Access Compliance Report

Public Rights-of-Way

Intersection ID: 45240	Main Street: BEGONIA_DR	Cross Street: BLAZE_MANOR_LN	Location:	N
ADA ID: 43D31868DCD5	Ramp Type: PerpDiag	Initial Pass/Fail: Pass	Overall Compliance: No	Severity Score: 12.5
Codes/Mitigation Info/Possible Solution		Field Measurements/Component Compliance

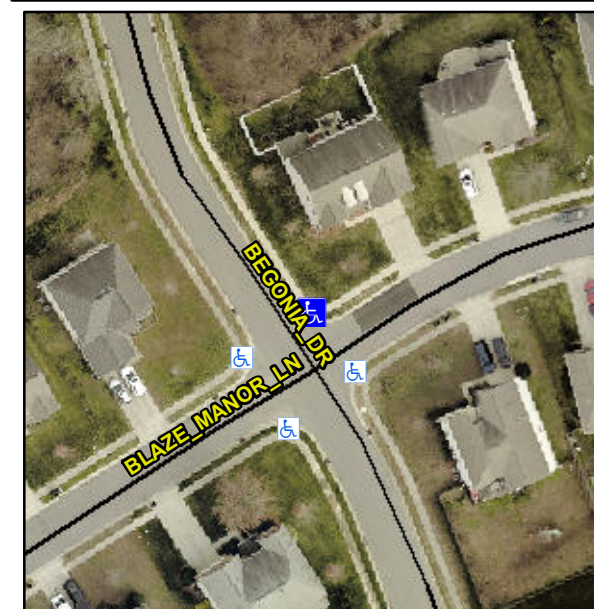
Not Found, R302.7, R302.7.2, R304.5.4

Compliance	Description	Data	Compliance	Description	Data
N/A	Ramp Length (in)	48.0	Yes	Ramp Slope (%)	5.8
Yes	Ramp Width (in)	48.0	Yes	Ramp XSlope (%)	0.1
N/A	Flare Type LT	Sloped	N/A	Flare Type RT	N/A
N/A	Flare Slope LT (%)	4.9	N/A	Flare Slope RT (%)	5.5
N/A	Flare Traversable LT?	No	N/A	Flare Traversable RT?	No
Yes	Landing Length (in)	48.5	Yes	DWS Provided?	Yes
Yes	Landing Width (in)	48.0	Yes	DWS Contrast?	Yes
Yes	Landing Slope (%)	0.8	Yes	DWS Length (in)	24.5
Yes	Landing X Slope (%)	0.1	Yes	DWS Full Width?	Yes
N/A	Landing Curb? (Y/N)	No	Yes	DWS Offset (in)	1.0
N/A	Shared Landing?	No			
No	Gutter Ponding?	Yes	No	Gutter Slope (%)	16.6
No	Gutter Lip Ht (in)	0.5	Yes	Gutter X Slope (%)	0.7
N/A	Painted X Walk1?	No	N/A	Painted X Walk2?	No
	X Walk 1 Direction	To SW		X Walk 2 Direction	To SE
N/A	X Walk 1 Width (in)	N/A	N/A	X Walk 2 Width (in)	N/A
	X Walk 1 Slope (%)	3.7		X Walk 2 Slope (%)	4.0
	X Walk 1 X Slope (%)	1.1		X Walk 2 X Slope (%)	1.3

N/A	Ramp inside XWalk1?	N/A	N/A	Ramp inside XWalk2?	N/A
	Road Slope (%)	0.9	N/A	Clear Space?	Yes
	Road X Slope (%)	2.9	N/A	Clear Space to XWalk (in)	N/A
Yes	Any Obstructions?	No	Yes	Storm Grate/Utility Hazard?	No
	Obstruction Type			Storm Grate/Utility Type	
		N/A			N/A
			Yes	Surface Condition? (G/P)	Good

Remove & Replace Curb Slope and Extend Ramp. Remove & Replace Gutter.
